RESOURCE CONSENT APP.041707.01.01 KERIKERI LAND LTD

KERIKERI RETIREMENT VILLAGE, STORMWATER DISCHARGE

Appendix A: NRC Hydrologist Comments on Haigh Workman report

Comments on Haigh workman report

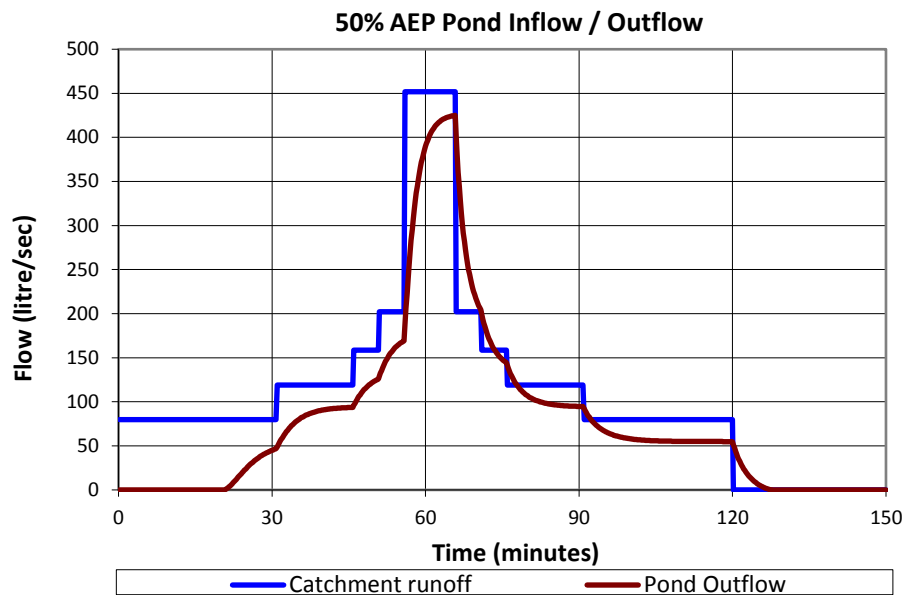
Stormwater attenuation achieved through soakage and detention in a 10% AEP + CC rainfall event for a typical pond (Pond 3) is shown graphically below:

It can be seen that in a 10% AEP rainfall event, peak runoff is reduced by around 10%, but there is little delay in the discharge.

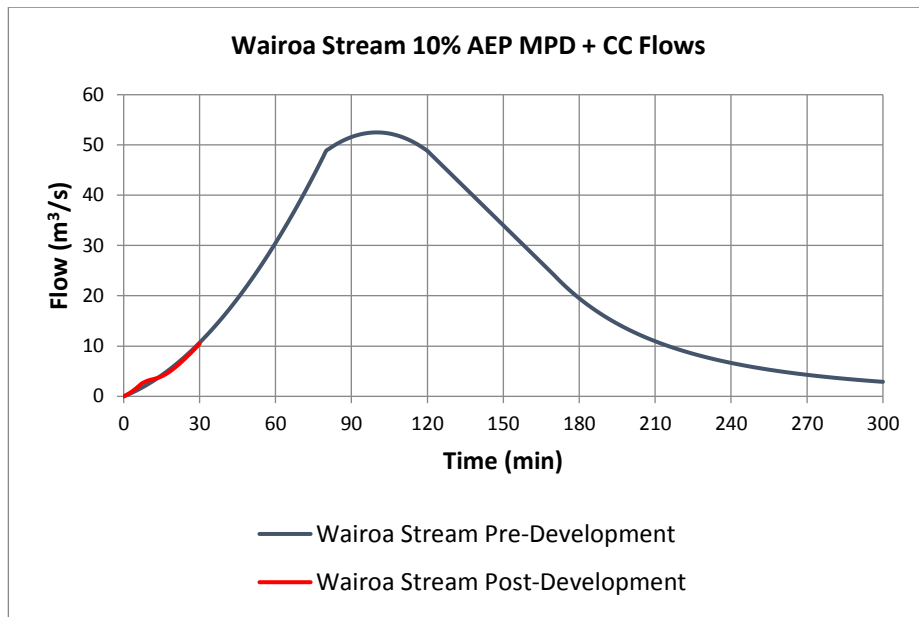
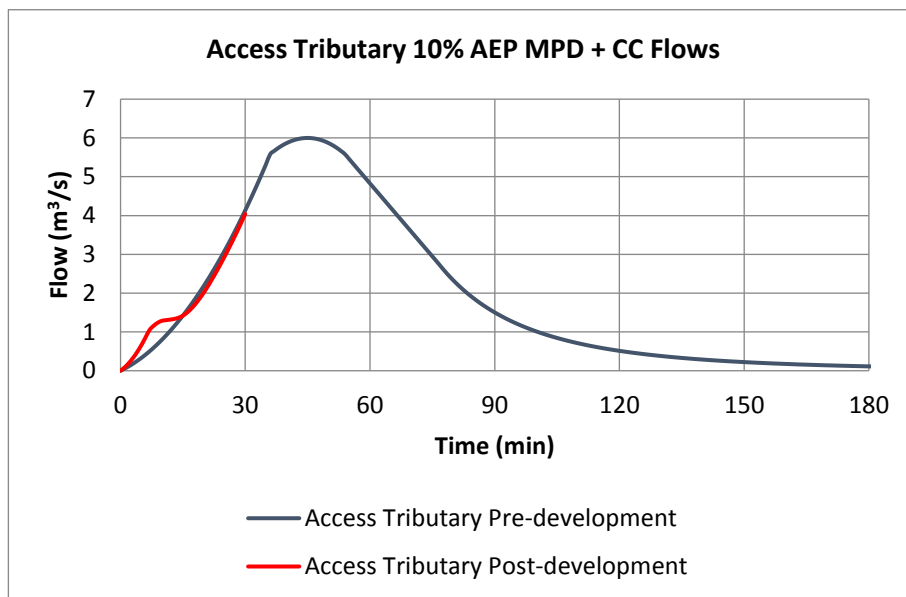
The effect of the increased site runoff to the Wairoa Stream upstream of the tributary junction for the 10% AEP + CC rainfall event is illustrated below:

Similarly, the effect of the increased site runoff to the Access Tributary for the 10% AEP + CC rainfall event is illustrated below:

In each case, the changes to stream flow are minor and occur at the early stages of a flood event so do not add to peak flow.

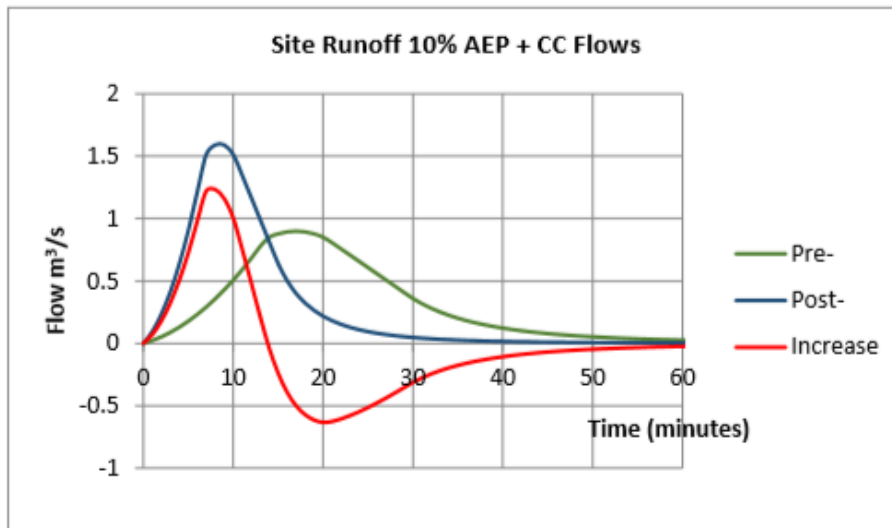
The post-development scenario will have very minor effect on the flood peaks in the streams for a 10yr ARI and larger events (100year ARI). However, without attenuation, it could have adverse effects on downstream flooding for more frequent events (1 to 2-year ARI). There is no evidence in the report to justify that the more frequent events will not exacerbate the downstream flooding. Without attenuation, it could result in increased flood depth and duration for those properties that are at flood risk for more frequent events.

For example, Looking at the following hydrograph from the report, it suggests that the discharge from the site will only affect the early part of the flood hydrograph with very minor effects on the river flood peak but for smaller events where the river flood peak will be low enough, the effect of the storm water discharge from the site will be more obvious.

1. Provide some attenuation to bring the post-development discharge hydrographs from the site to be closer to pre-development scenario but also make sure the peaks do not coincide with the flood peak in the river.

Some attenuation (approximately 10 minutes) could bring the post-development discharge hydrograph to match pre-development discharge hydrograph from the site as per the below graphs from the report.

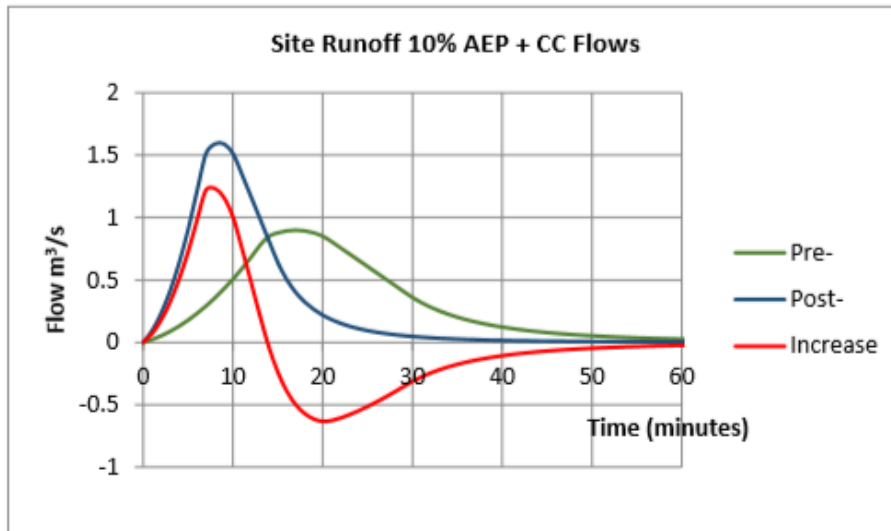
The post-development scenario will have very minor effect on the flood peaks in the streams for a 10yr ARI and larger events (100year ARI). However, without attenuation, it could have adverse effects on downstream flooding for more frequent events (1 to 2-year ARI). There is no evidence in the report to justify that the more frequent events will not exacerbate the downstream flooding. Without attenuation, it could results in increased flood depth and duration for those properties that are at flood risk for more frequent events.

For example, Looking at the following hydrograph from the report, it suggests that the discharge from the site will only affect the early part of the flood hydrograph with very minor effects on the river flood peak but for smaller events where the river flood peak will be low enough, the effect of the storm water discharge from the site will be more obvious.

1. Provide some attenuation to bring the post-development discharge hydrographs from the site to be closer to pre-development scenario but also make sure the peaks do not coincide with the flood peak in the river.

Some attenuation (approximately 10 minutes) could bring the post-development discharge hydrograph to match pre-development discharge hydrograph from the site as per the below graphs from the report.
